# BCA - DDA/ACCESS COMPLIANCE REVIEW

Manly Corso Apartments Refurbishment

**ISSUE B**

DATE 1<sup>ST</sup> MAY 2019

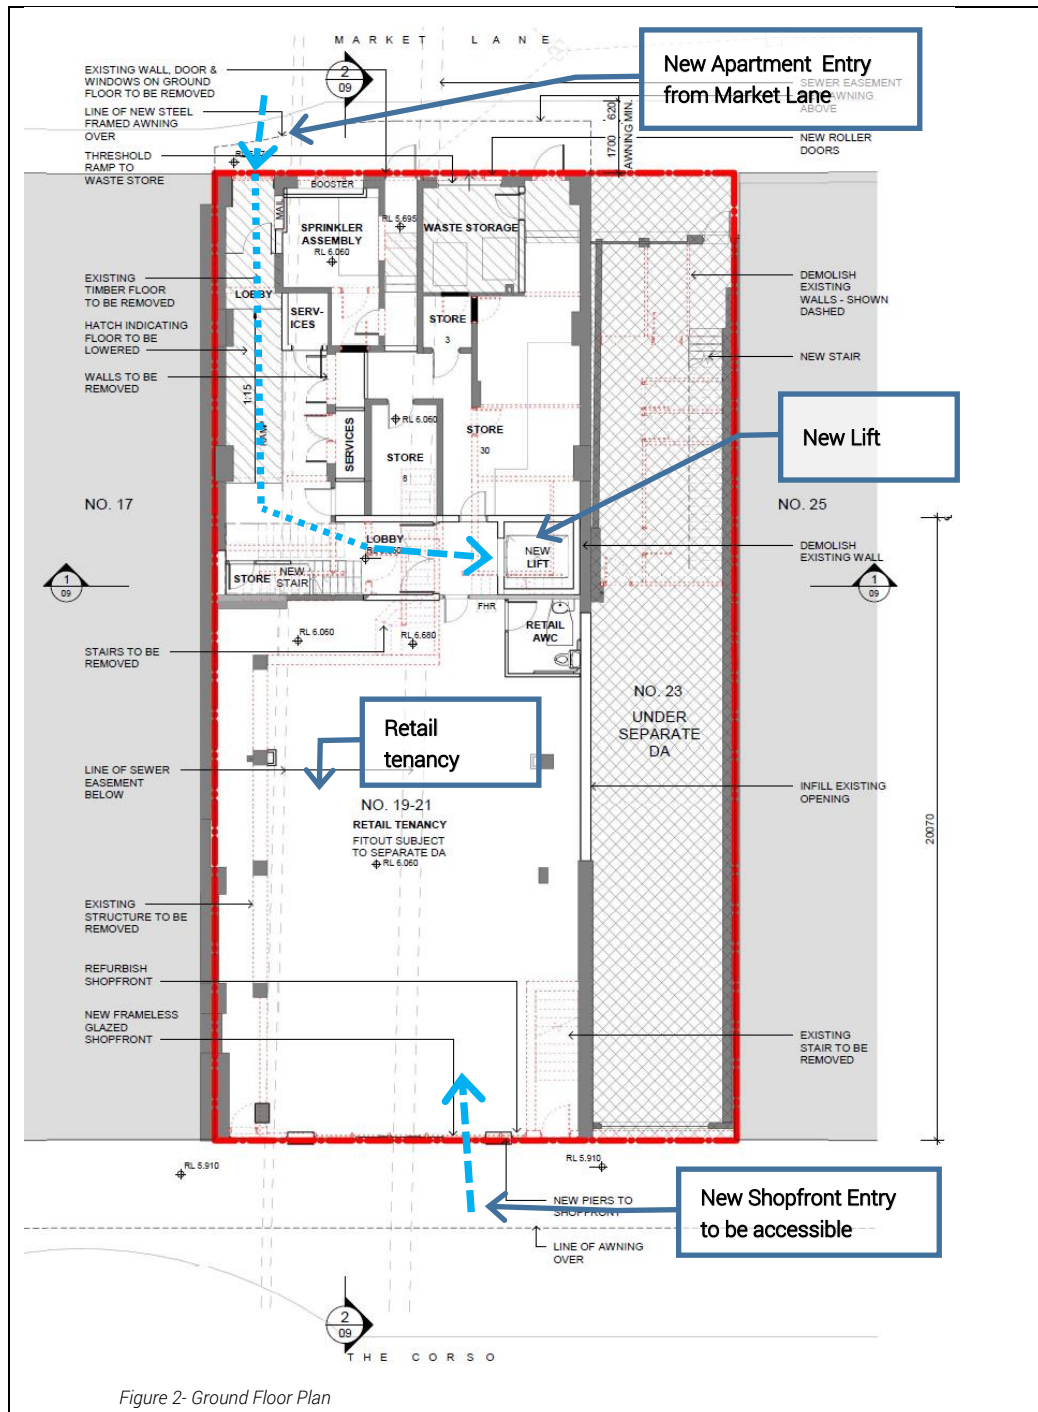
Within the current design there are two entries to the building, being;

- the entry to the retail tenancy from The Corso street frontage
- The entry to the apartment lift lobby from the Market Lane street frontage.

Both entries are at grade and could be provided with an accessible entry, subject to the detailed design, therefore 100% of entries could be accessible and therefore the design could meet the requirements of Clause D3.2

Figure 3- Ground Floor Plan

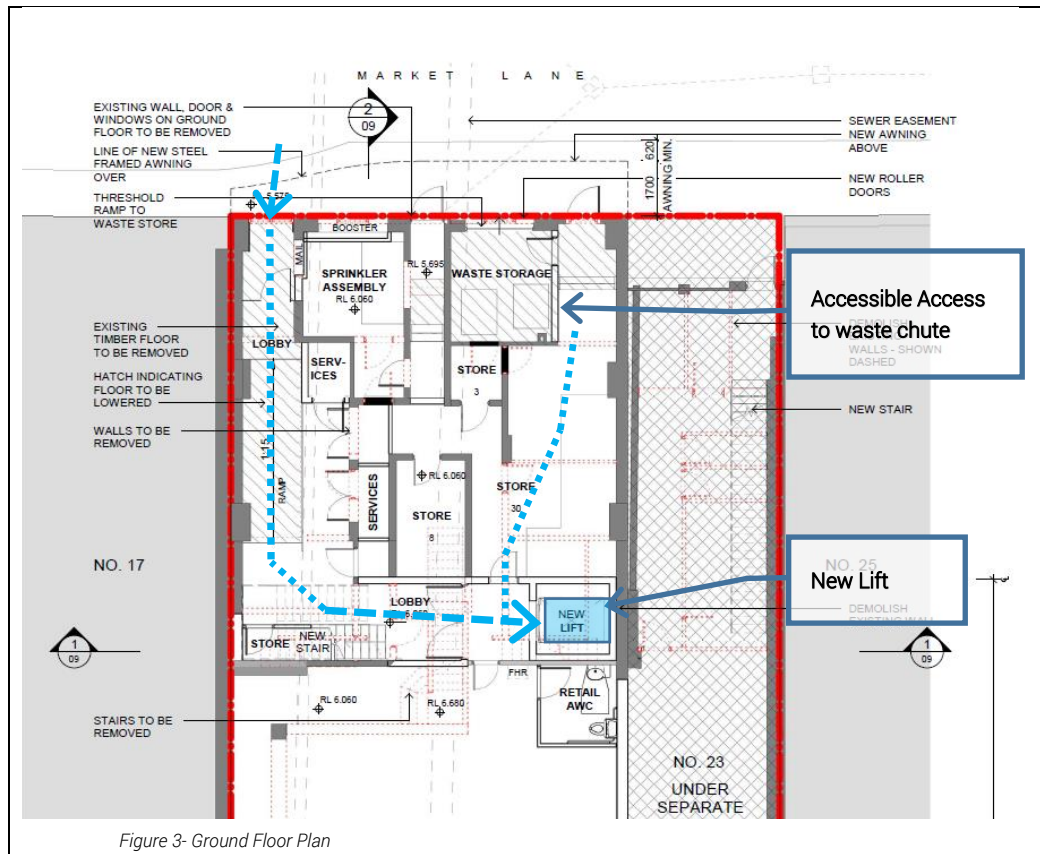
The proposed common areas to the ground floor are to be provided with an accessible path to the lift and from the lift to the storage areas and to the waste area. The existing design includes a waste chute which is within an accessible area of the storage area. New doors within this area are to have a minimum 850mm clear doorway opening width.
